TO: John Sponseller
FROM: Carson Byerhof, Planner I
DATE: July 28, 2022
SUBJECT: SP22-041 – Dunkin Donuts
Review Comments 01

**SITE PLAN FOR
DUNKIN' DONUTS
DOUGLAS 234, FILING NO. 6,
AMENDMENT 1, LOT 4**

COVER SHEET

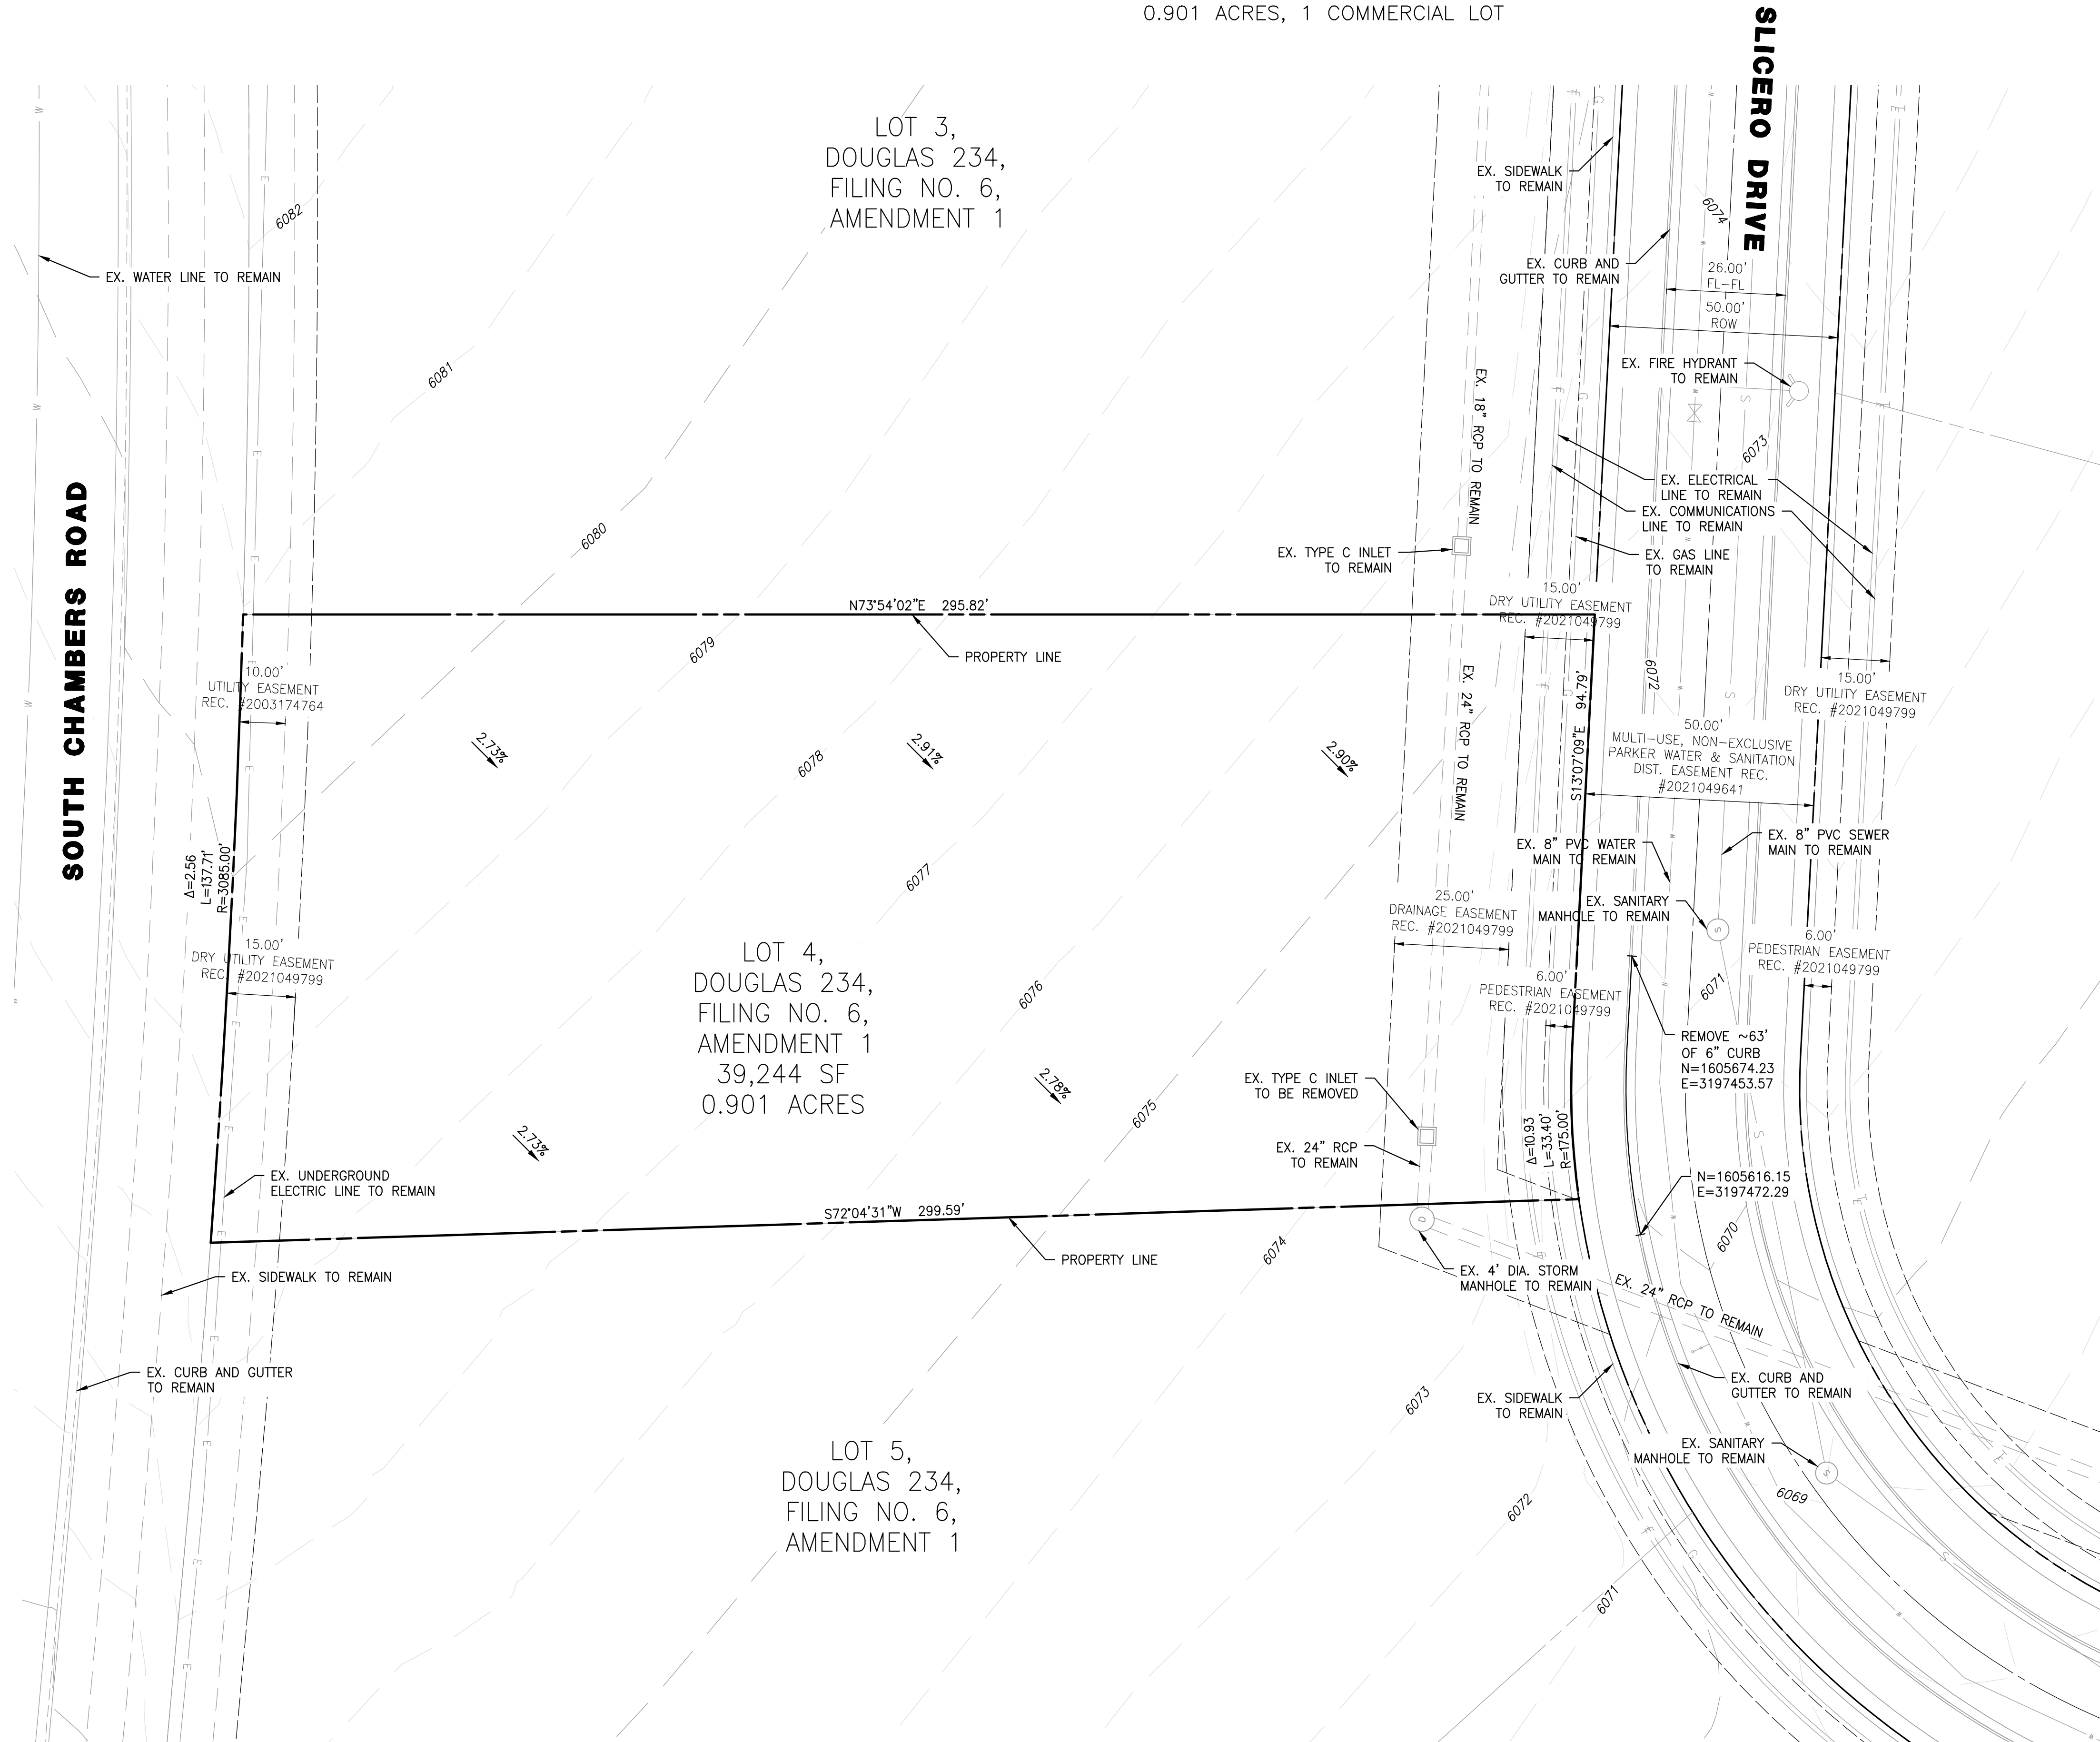
Is indoor seating included with this establishment? Will need to be 1/3 person seating capacity if so
RESPONSE: WE ARE NOW PROVIDING 18 SPACES AS THE NLA IS LESS THAN PREVIOUSLY. WE ARE CALCULATING THE PARKING REQUIRED WITH THE 1 SPACE PER 100 NLA AS THIS GIVES US A GREATER NUMBER OF REQUIRED SPACES.

Stand alone eating and drinking establishments require 4

RESPONSE: UPDATED PLANS TO SHOW 4 BICYCLE PARKING SPACES AND UPDATED SITE DATA.

**SITE PLAN FOR
DUNKIN' DONUTS
DOUGLAS 234, FILING NO. 6,
AMENDMENT 1, LOT 4**

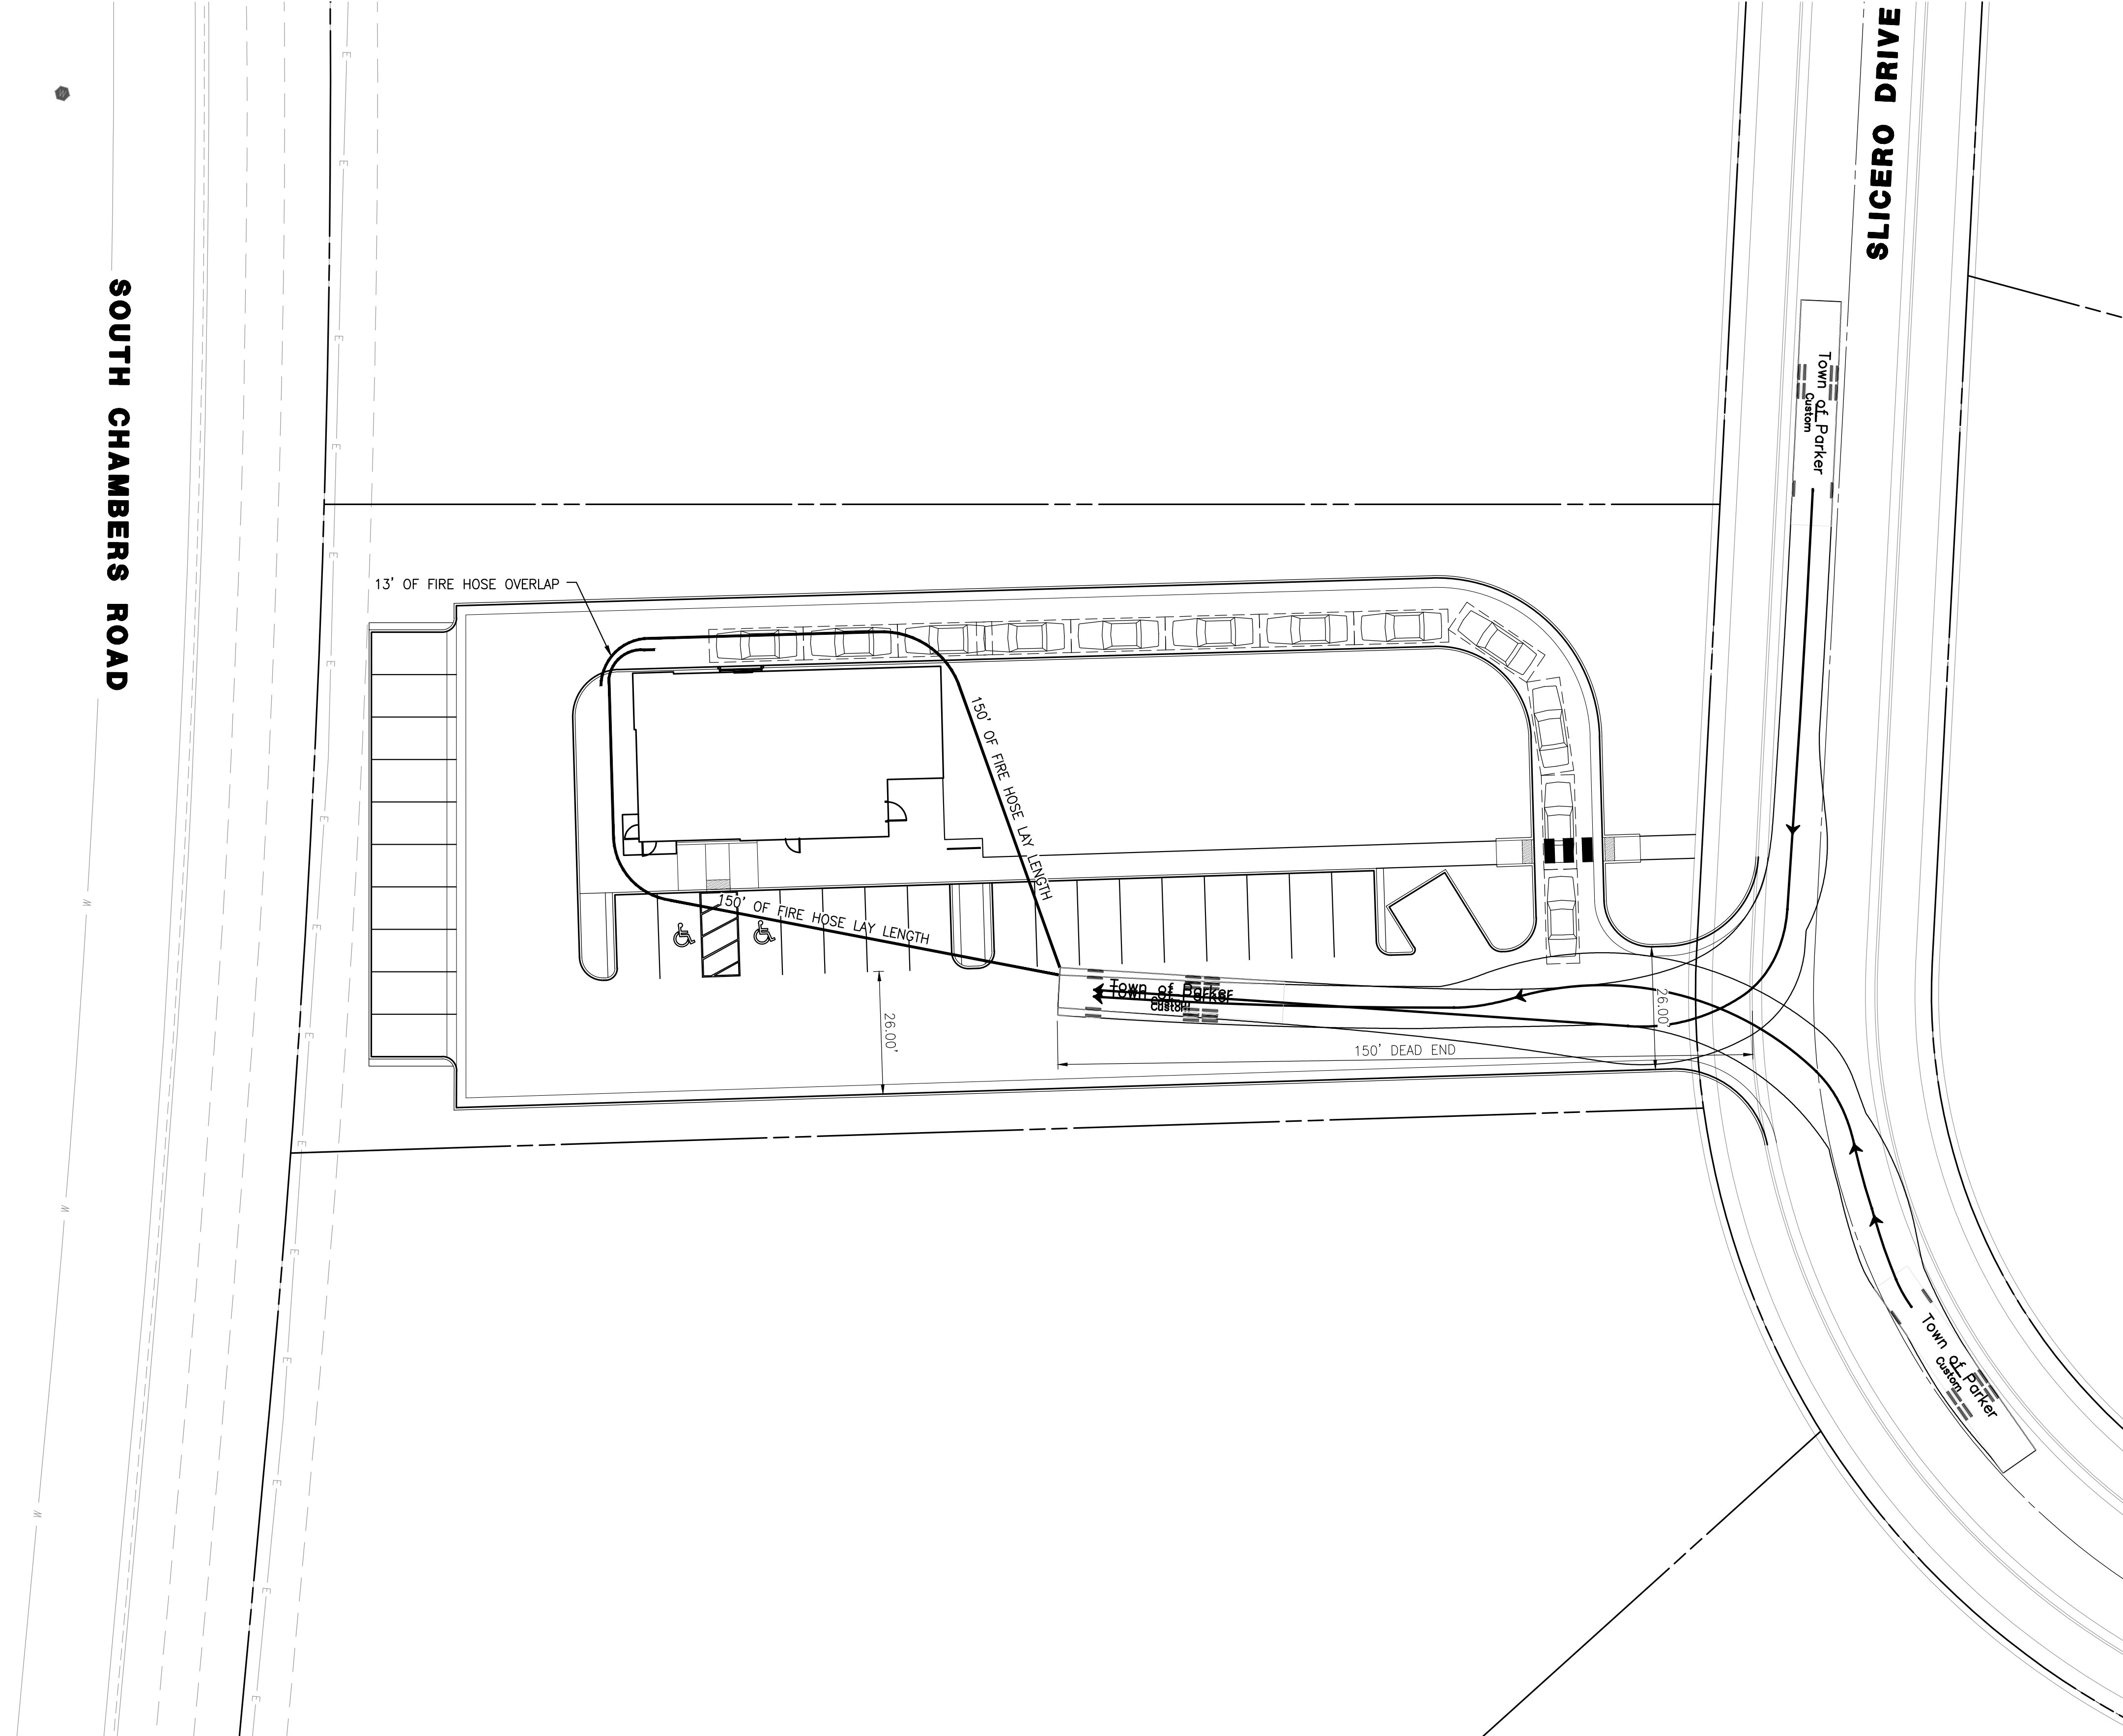
Need to show more detailed context of 50' around lot line (ROW sidewalks and streets and streetscape planting details mainly)

Provide pedestrian crossing and sidewalk connection to Chambers
RESPONSE: PROVIDED A PEDESTRIAN WALK CONNECTION TO CHAMBERS.

Include dimensions/construction-type callout for 18" concrete landings for parking stalls next to landscaped areas
RESPONSE: ADDED A CONSTRUCTION CALLOUT FOR THE 18" CONCRETE LANDINGS.

sidewalk and crossing required along Slicero
RESPONSE: ADDED PEDESTRIAN RAMPS FOR THE CROSSINGS ALONG SLICERO.

↔ = add dimensions
RESPONSE: NOTED AND ADDED DIMENSIONS OF THE BUILDING AND TO THE PROPERTY BOUNDARY.

RESPONSE: NOTED AND UPDATED SITE PLAN TO ADD MORE DETAIL TO AROUND THE PROPERTY BOUNDARY.
